STRUCTURE CAST		
DATE:	08-08-22	REVISIONS		
DRAWN BY:	HS	NO:	DATE:	DESCRIPTION
CHECKED BY:	LG	1	01-30-24	REVISED AS NOTED
JOB NO:	21-109310			
OWNER:	SUNLINE TRANSIT AGENCY			
ENGINEER:	BMI Consulting			
CONTRACTOR:	THREE PEAKS			
PROJECT:	SUNLINE COACHELLA HUB EAST-SET BUILDING 22'-8" x 22'-0"			
EXTERIOR ELEVATIONS				
DWG NO:	A-03			1

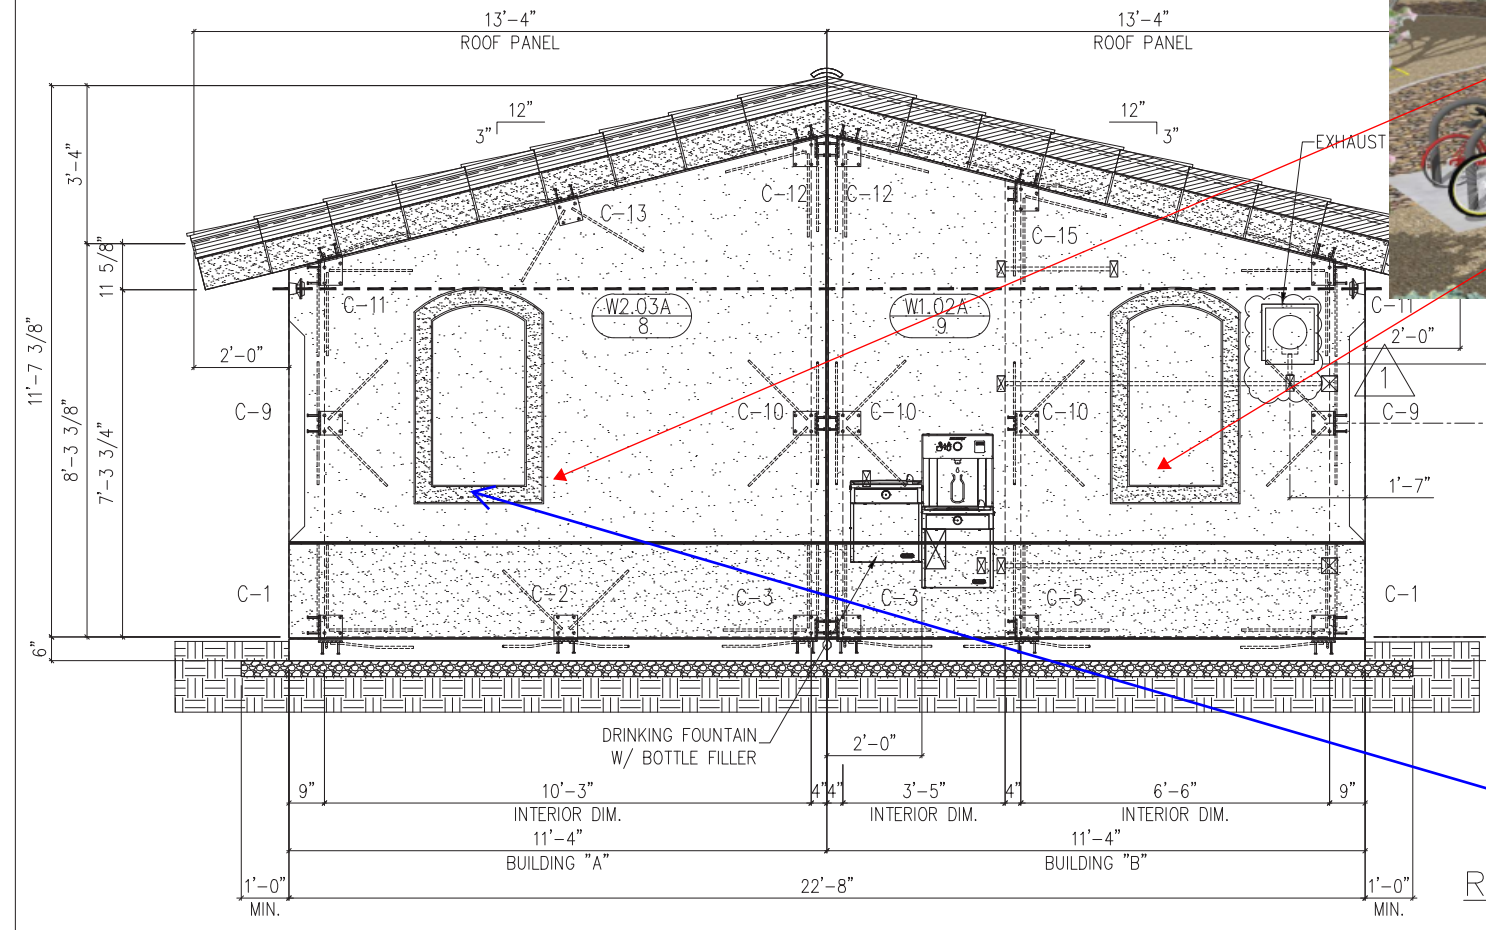
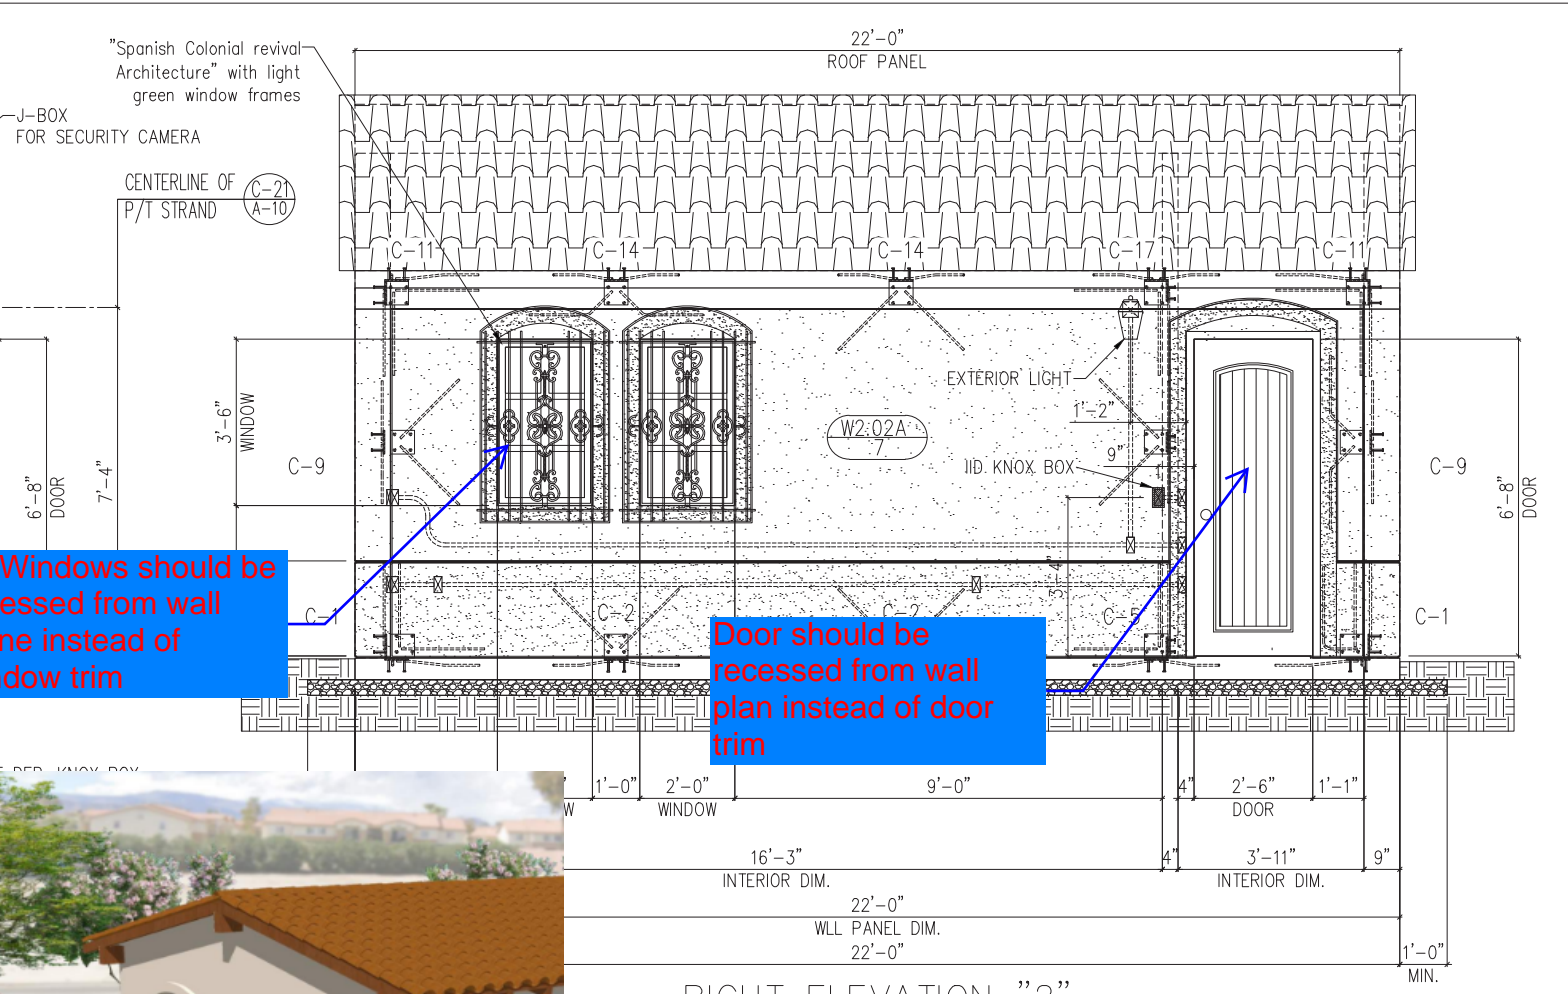
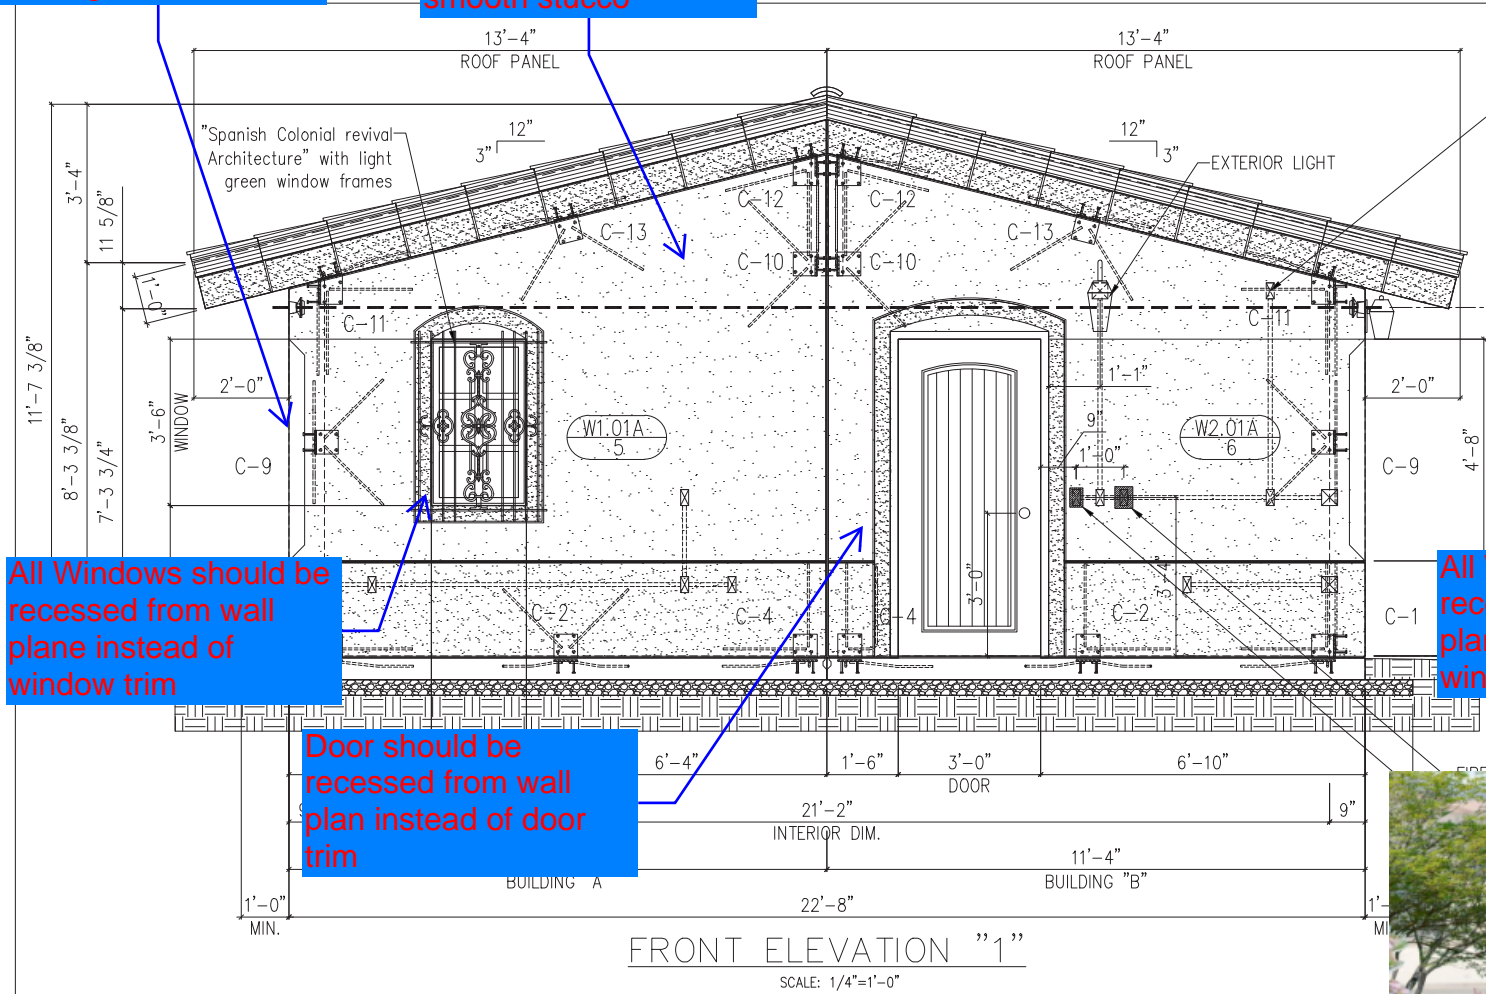
Bull nose corners at all building corners

Stucco shall be smooth stucco

All Windows should be recessed from wall plane instead of window trim

Door should be recessed from wall plane instead of door trim

All Windows should be recessed from wall plane instead of window trim

Door should be recessed from wall plane instead of door trim

Reject approval and provide detail of tiles.
